**DOCUMENT 00 90 00
ADDENDUM**

ADDENDUM NO. [1] Date: August 14, 2019

**RE: LANESBORO PUBLIC SCHOOLS
 ADDITION AND REMODEL
 100 KIRKWOOD ST EAST
 LANESBORO, MN 55949
 HSR 18063**

**FROM: HSR Associates, Inc
 100 Milwaukee Street
 La Crosse, WI 54603
 (608) 784-1830**

E103L

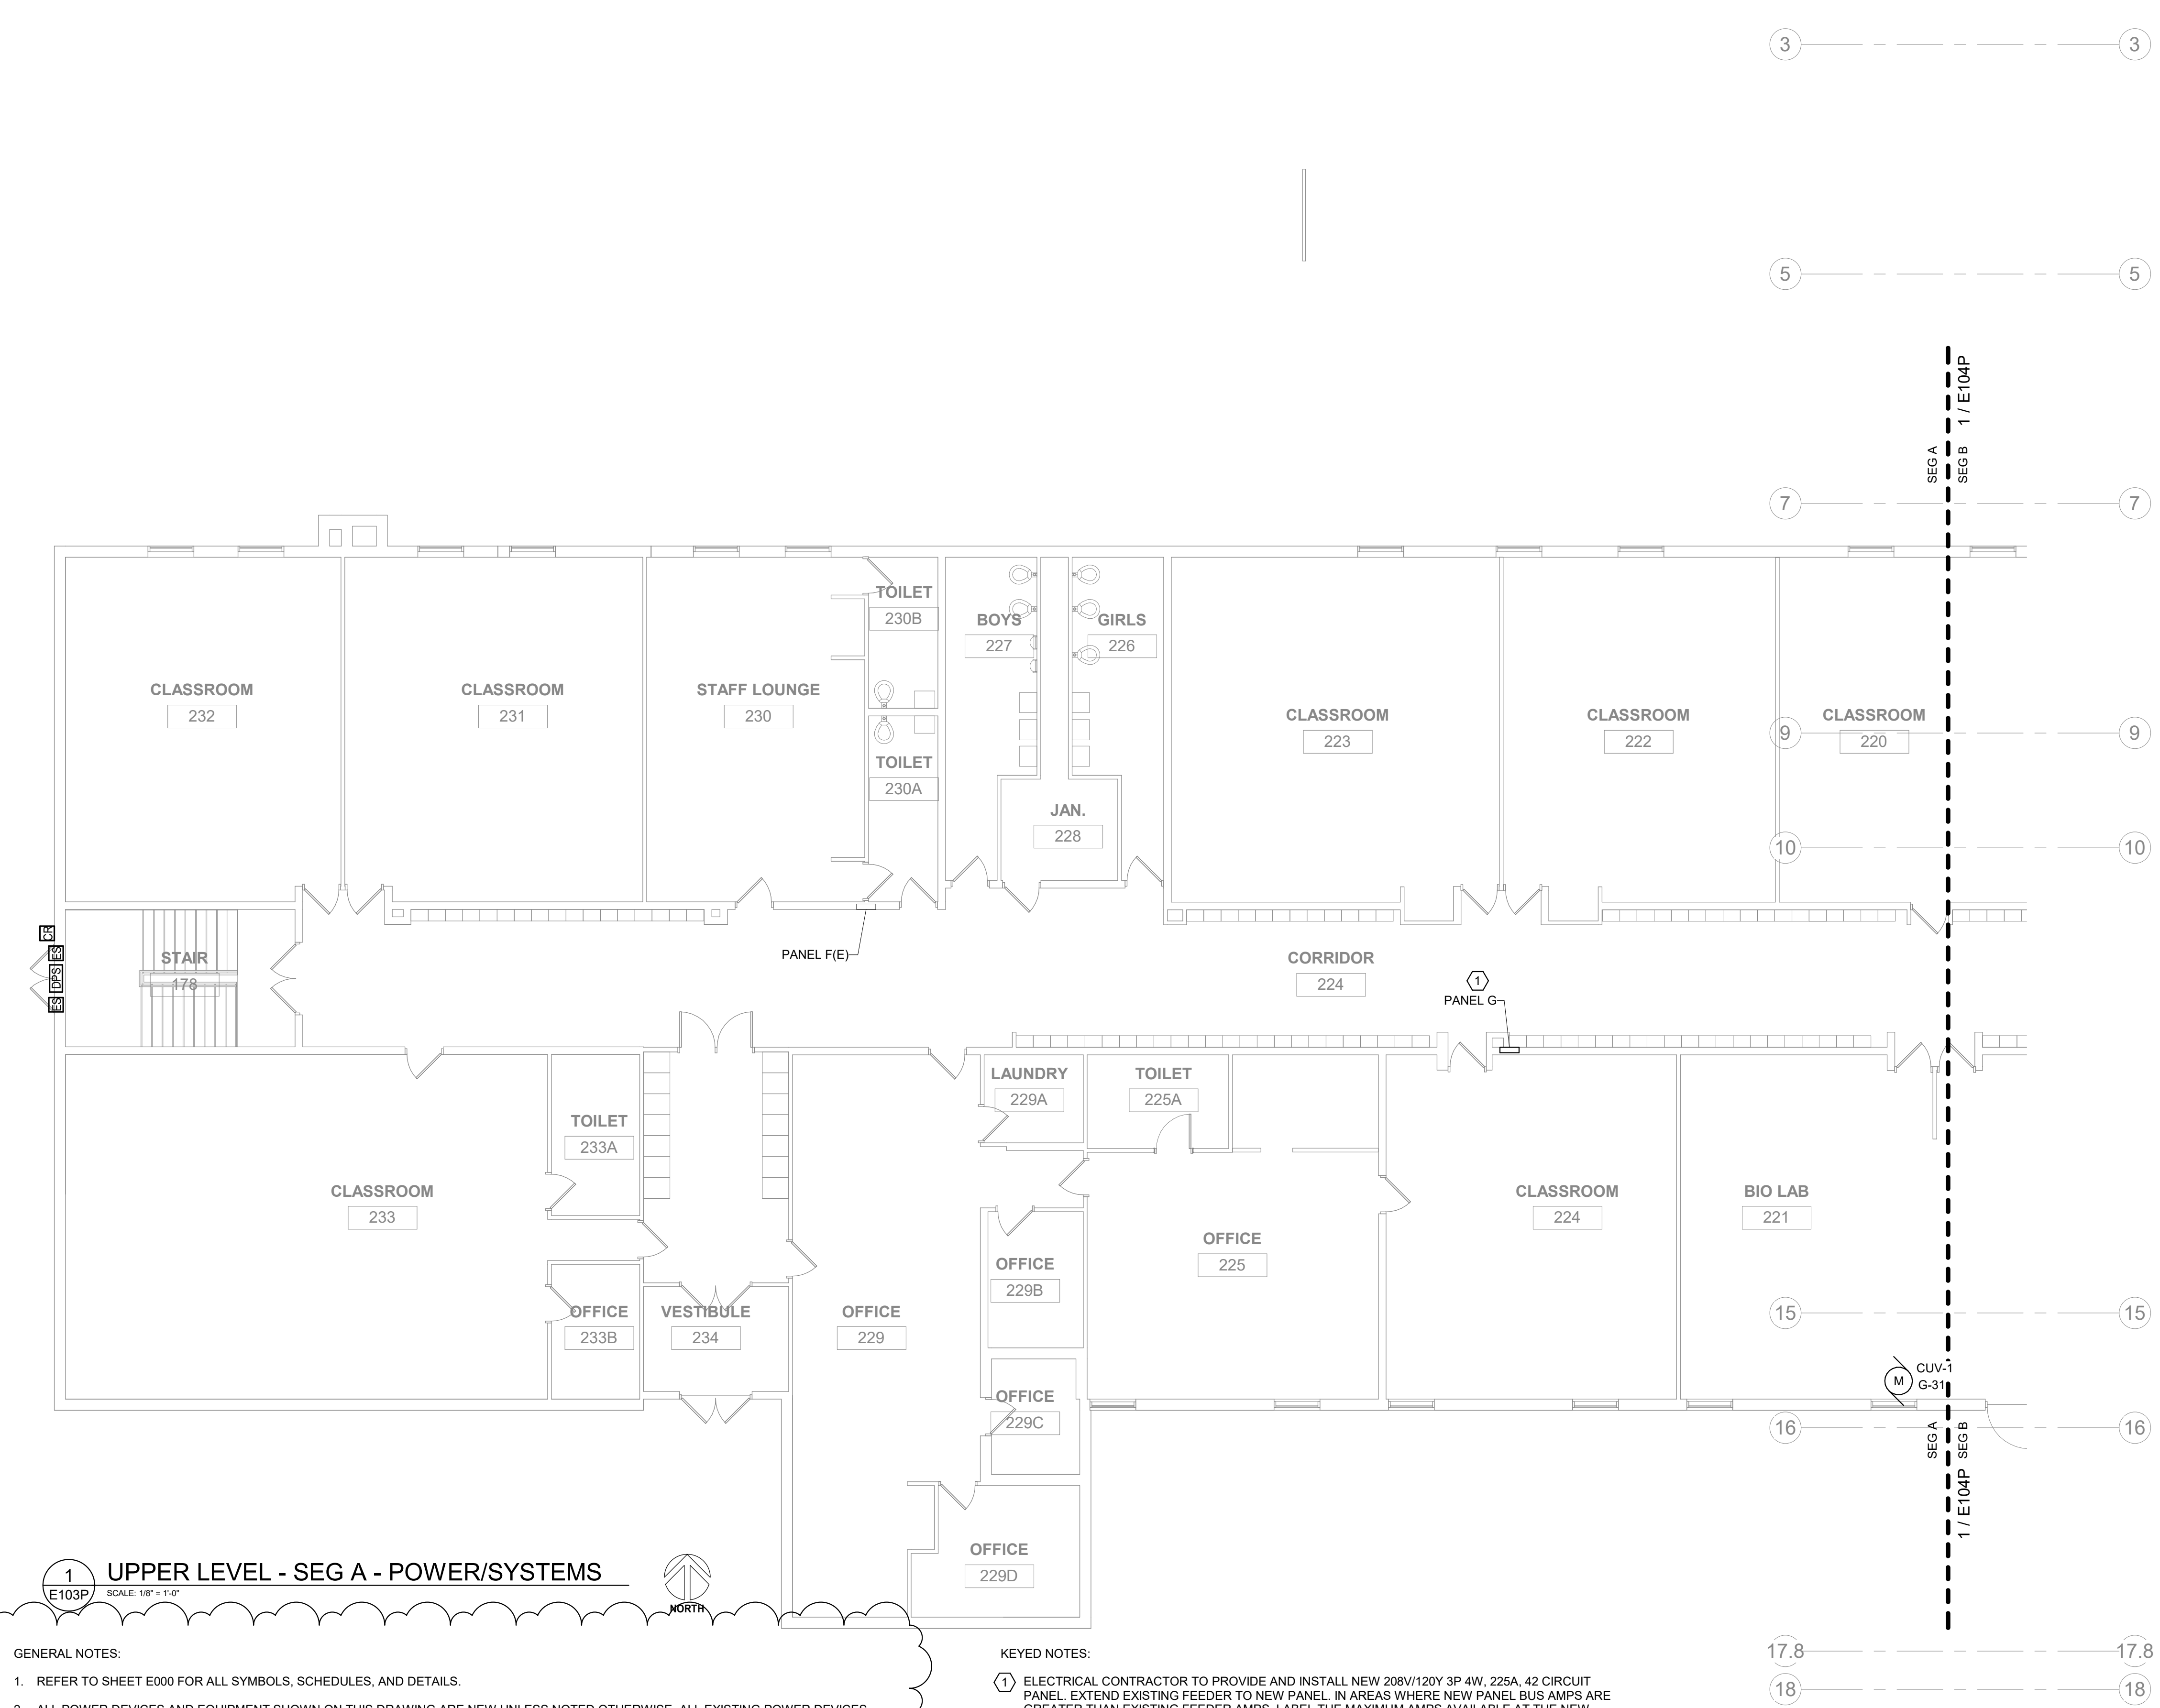
54. Sheet E103L UPPER LEVEL – SEGMENT A – LIGHTING 30 x 42 attached hereto
 - a. Revisions clouded on Drawing.
 - b. Revise general lighting notes, as shown.

- c. Remove unused keyed note, as shown.
55. Sheet E103P UPPER LEVEL – SEGMENT A – POWER/SYSTEMS 30 x 42 attached hereto
 - a. Revisions clouded on Drawing.

E103P

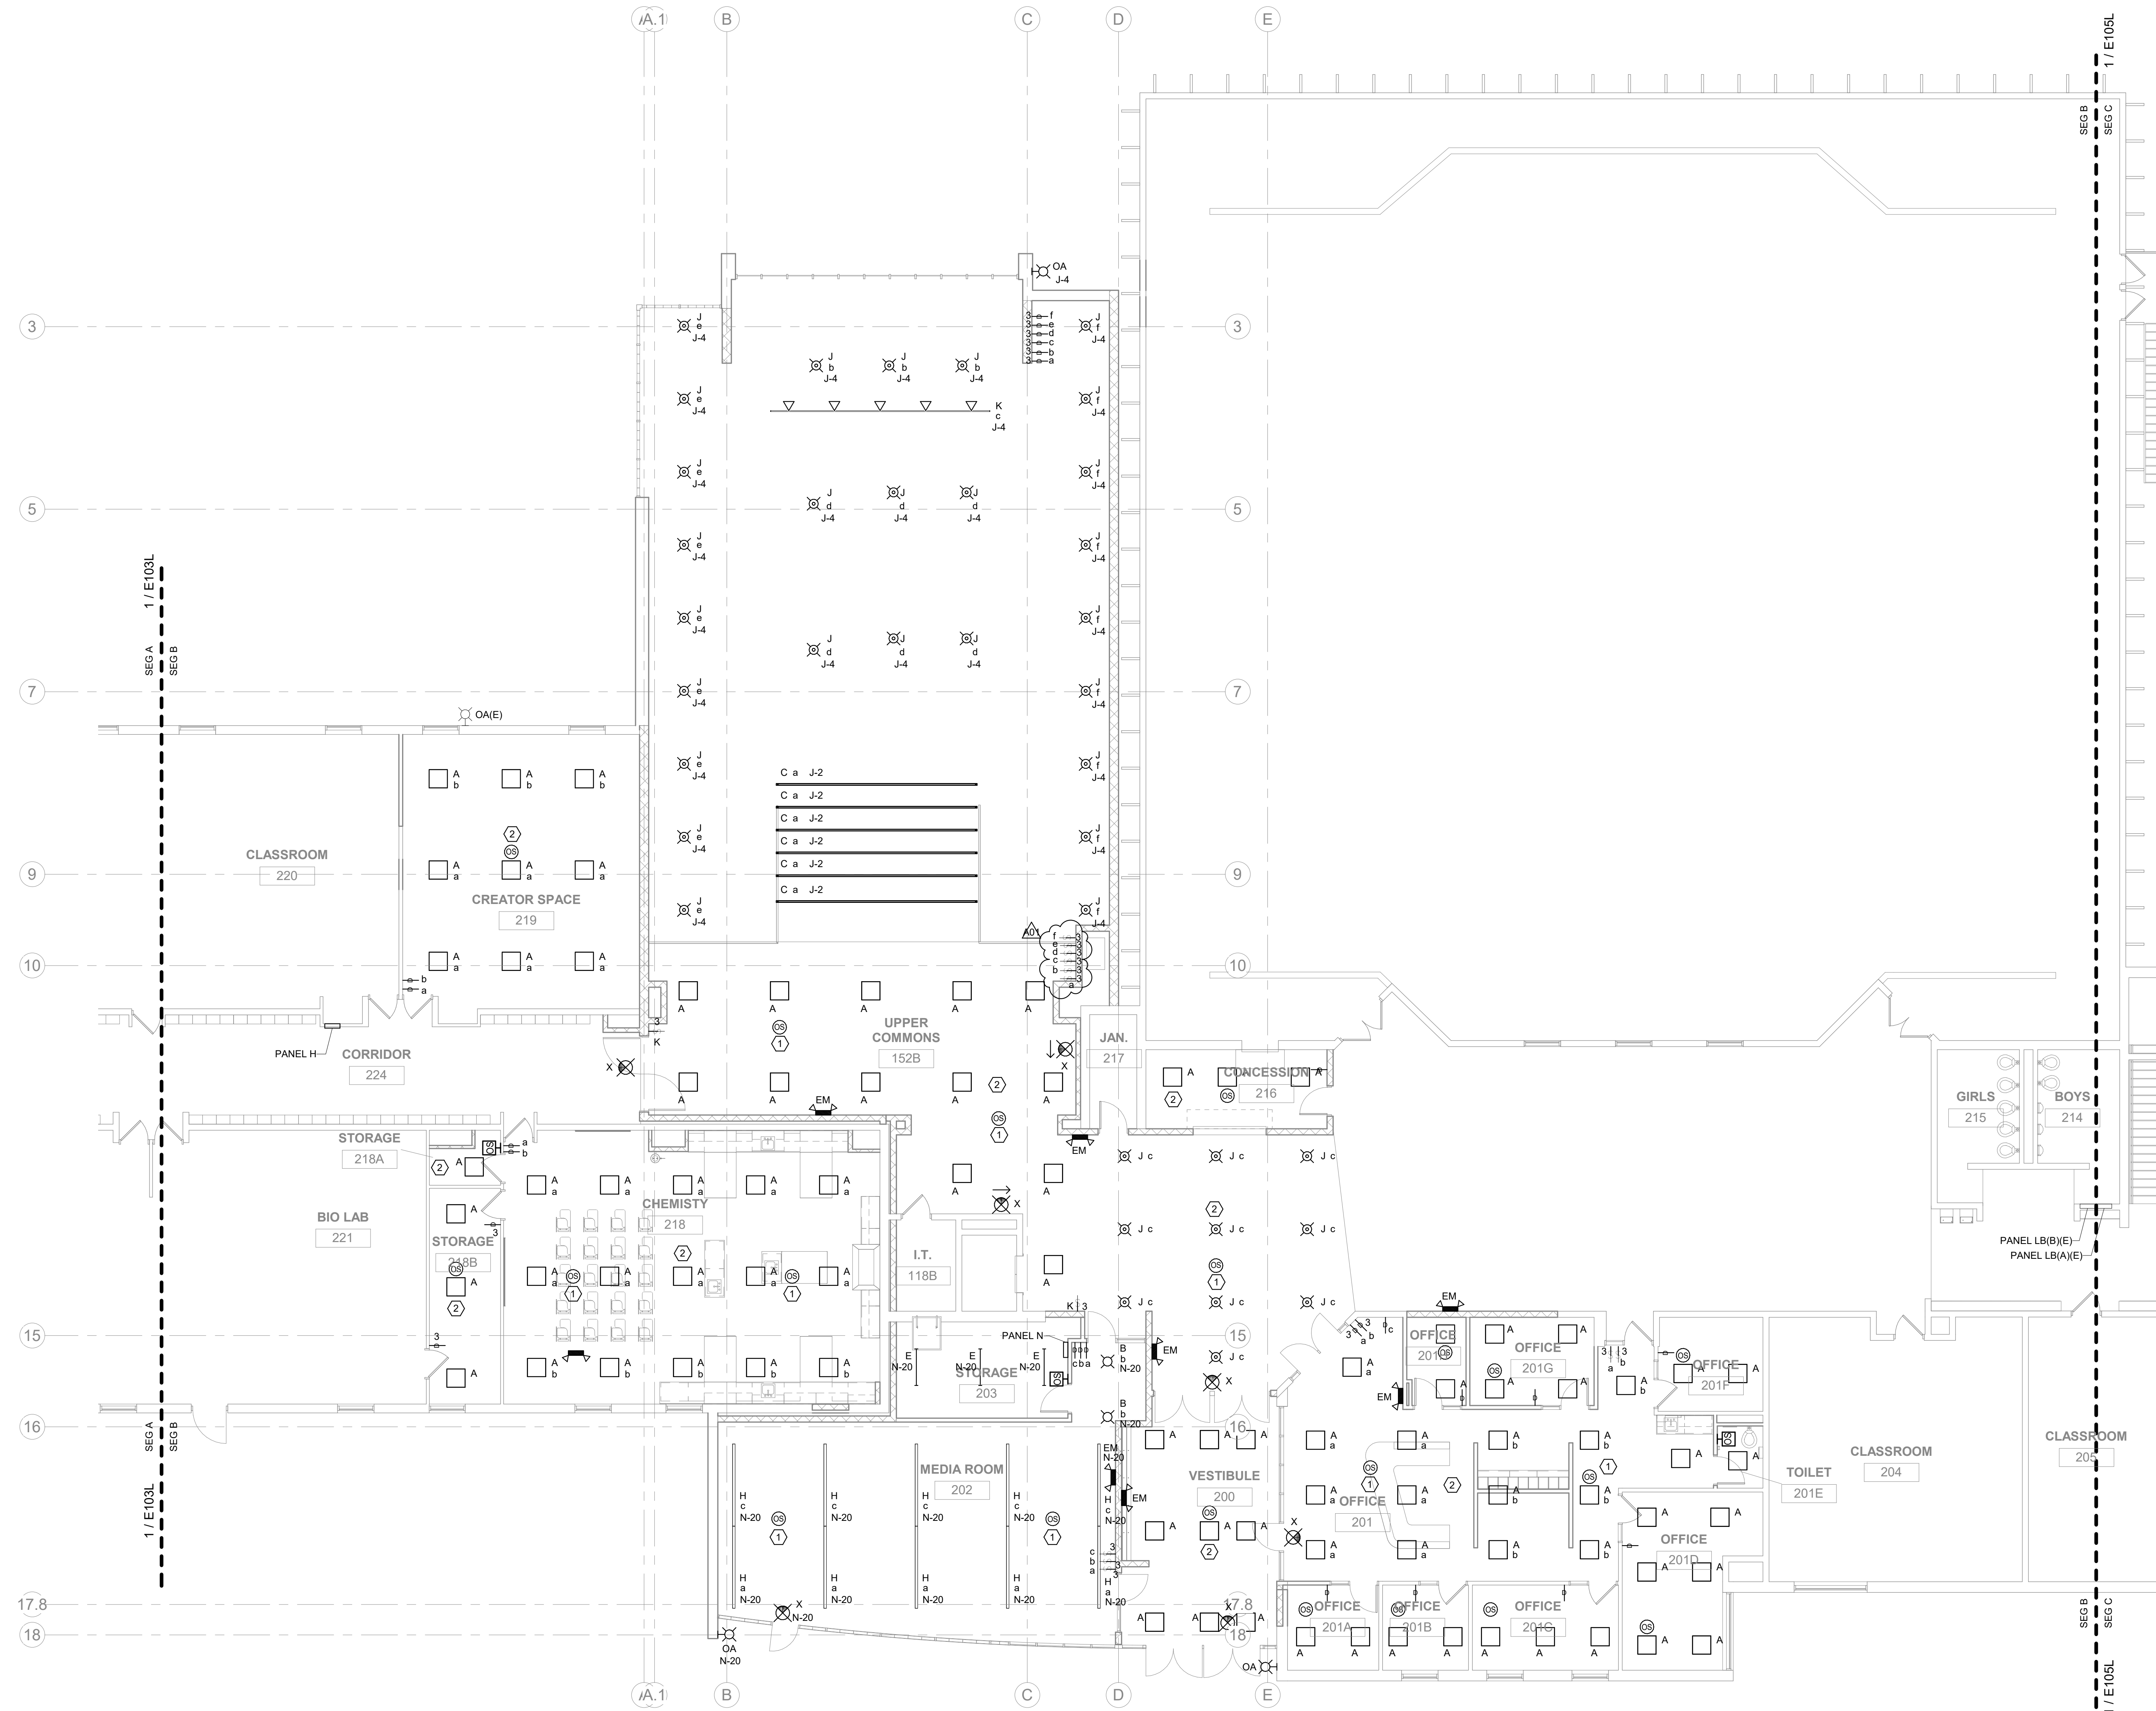
- b. Revise general power notes, as shown.
56. Sheet E104L UPPER LEVEL – SEGMENT B – LIGHTING 30 x 42 attached hereto
 - a. Revisions clouded on Drawing.

E104L

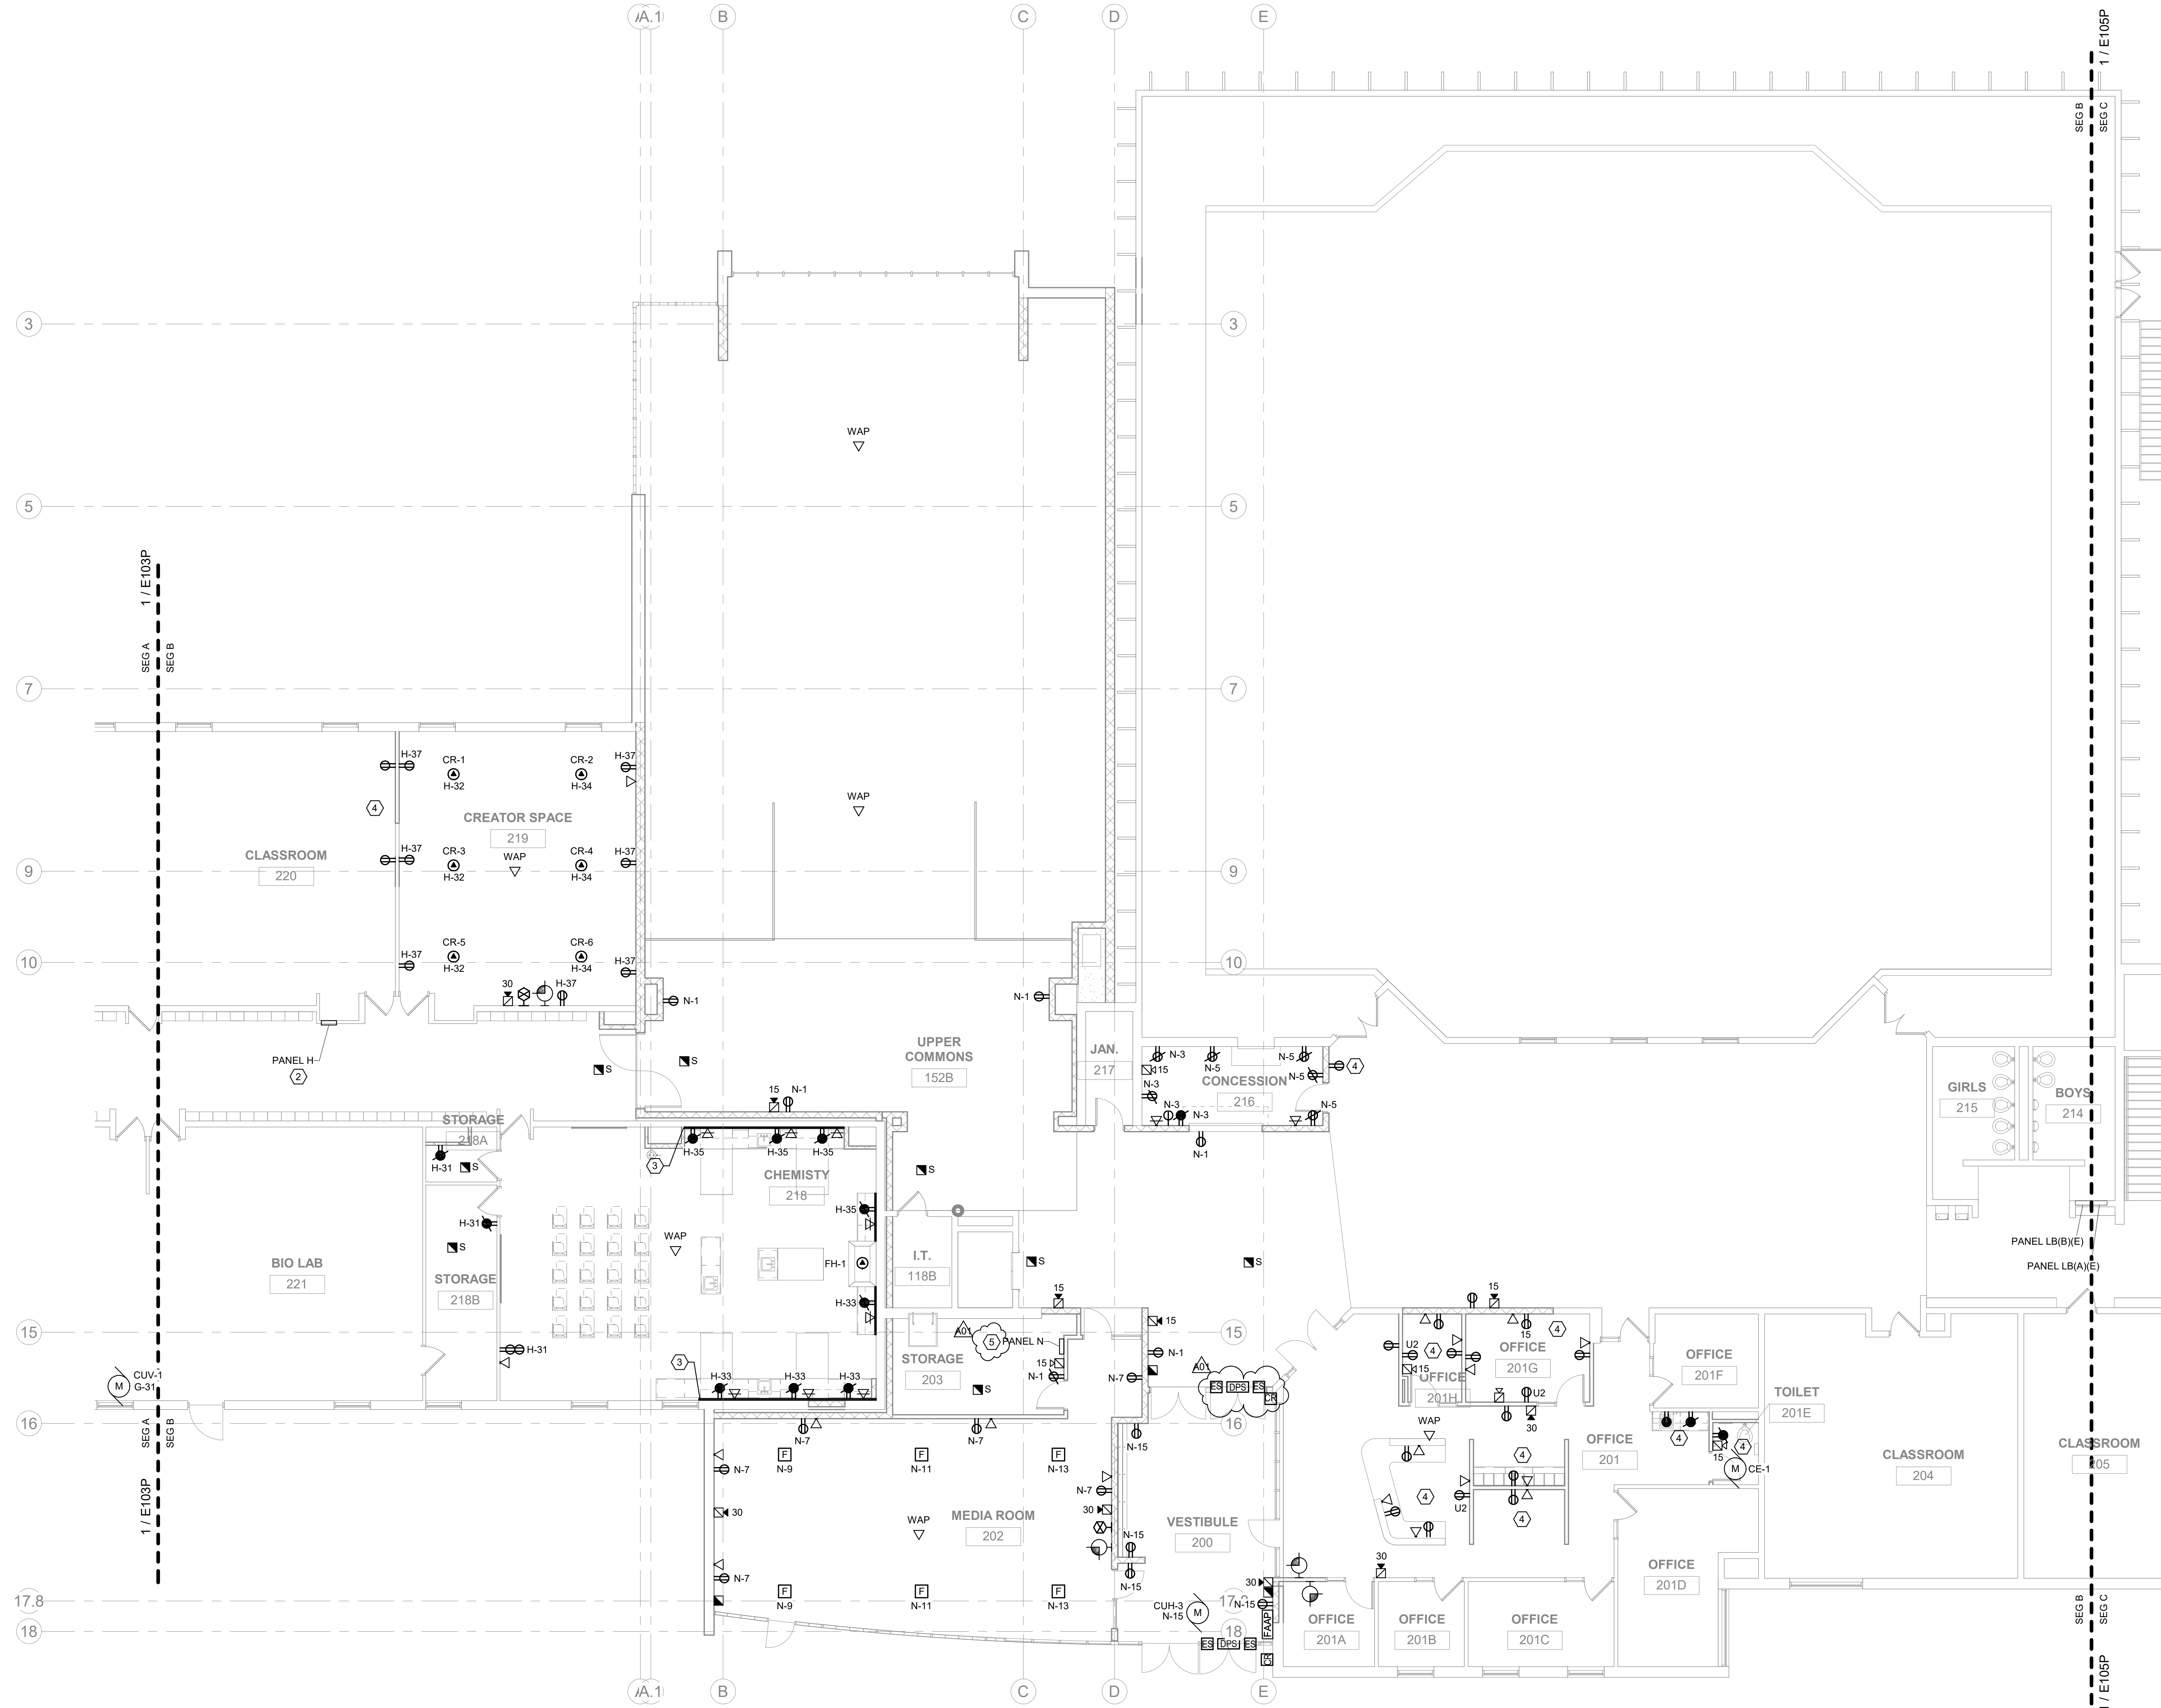
- b. Revise general lighting notes, as shown.
 - c. Revise light switch locations in Upper Commons 152B, as shown.
57. Sheet E104P UPPER LEVEL – SEGMENT B – POWER/SYSTEMS 30 x 42 attached hereto
